RS-03-232

Subject: Additional Information for the Review of the License Renewal Applications for Dresden Nuclear Power Station, Units 2 and 3 and Quad Cities Nuclear Power Station, Units 1 and 2

Attachment : Response to Request for Additional Information – LRA Sections 2.4, 3.2, 3.5, 3.6, and 4.7, and Aging Management Programs

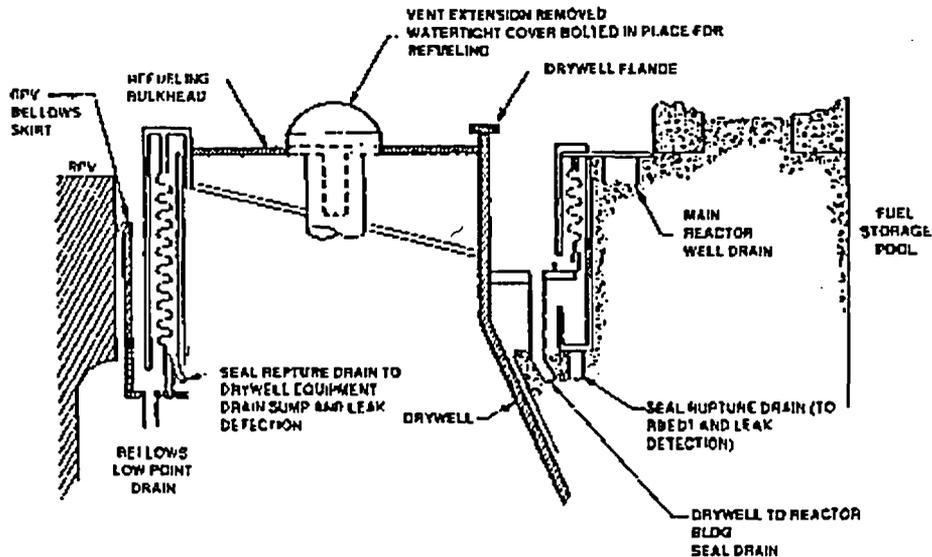
It is the staff's interpretation that the drywell-to-reactor building refueling seal and the RPV-to-drywell refueling seal are both brought into the license renewal scope by 10 CFR 54.4(a)(2). It is analogous to the seismic II/I requirements for license renewal. In this case, failure (leakage) of the non-safety components (refueling seals) has the potential to significantly degrade the function of the safety-related component (drywell). The staff's concern about the drywell-to-reactor building refueling seal is documented in Open Item 4.7.2.2-1, in the staff evaluation of the TLAA for Degradation Rates of Inaccessible Exterior Drywell Plate Surfaces.

From the applicant's response, it appears to the staff that leakage past the RPV-to-drywell refueling seal and subsequent discovery of this condition is not of great concern to the applicant. There apparently is no formalized procedure or requirement to check for leakage after flooding the reactor cavity. Water seepage past the moisture barrier at the steel/concrete juncture at the bottom on the inside of the drywell has the potential to initiate corrosion on the inside surface. Coupled with the known corrosive condition on the outside surface, continued demonstration of drywell structural adequacy would become more complex and uncertain.

The staff's position is that the RPV-to-drywell refueling seal is within the scope of license renewal and is subject to an aging management review. This is Open Item 2.4.1.2-1.

Exelon does not agree that performance of the drywell to refueling (DR) seals is a II over I issue. 10 CFR 54.4(a)(2) states, "All nonsafety-related systems, structures, and components whose failure could prevent satisfactory accomplishment of any of the functions identified in paragraphs (a)(1)(i), (ii), or (iii) of this section." A postulated failure of the DR seals can result in water intrusion into the annulus space around the drywell. This leakage can occur only during refueling outages when the reactor cavity is flooded to allow movement of fuel between the reactor and the fuel pool. However, water intrusion does not cause failure of the drywell's intended function. Any water leakage resulting from a postulated failure of the DR seals could not remain suspended in the annulus region for an indefinite period of time and would eventually be routed to the sandpocket area drains or would evaporate due to the heat generated in the drywell during operation. Regardless, Exelon will implement the drywell monitoring program outlined in the supplemental response 4.7.2.2-1 for the Dresden 3 drywell annulus areas to ensure that unacceptable corrosion is not occurring.

Leakage past the RPV-to-drywell refueling seal is collected and directly piped by design to the drywell equipment drain sump. Refer to the following drawing.

A high flow switch in the drain line to the equipment drain sump provides an alarm in the control room if flow >1 gpm is detected (there is an additional high level alarm on the sump itself). The annunciator response procedure directs actions to quantify/mitigate the leakage, since excessive flow through the drain line could eventually result in leakage into the drywell.
